Rezoning Transportation Analysis

Petition Number: 2019-085

General Location Identifier: 20145105

Date	Description
07-17-2019	First Review
09-24-2019	Second Review
10-22-2019	Third Review

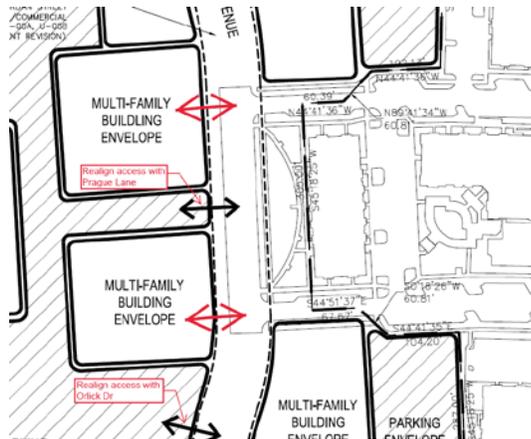
4. Steele Creek Area Plan
 - a. ~~The petitioner should revise the site plan and conditional note(s) to commit to construct an 8-foot planting strip, and 6-foot sidewalk on Arrowood Rd, per the Steele Creek Area Plan. CDOT requests for the back of 6-foot sidewalk to be placed 53 feet from centerline, to plan for a future 12-foot multi-use path. The site plan should label and dimension both items from the back of curb and gutter/road centerline.~~
 - b. ~~**Comment Revised/Outstanding**~~ The petitioner should revise the site plan and conditional note(s) to construct the future Arrowood Road/Whitehall Park Drive Connection to the intersection of the Savoy Corporate Drive's future extension alignment, per the Avenue — Two Lane Undivided cross section provided within the Steele Creek Area Plan.
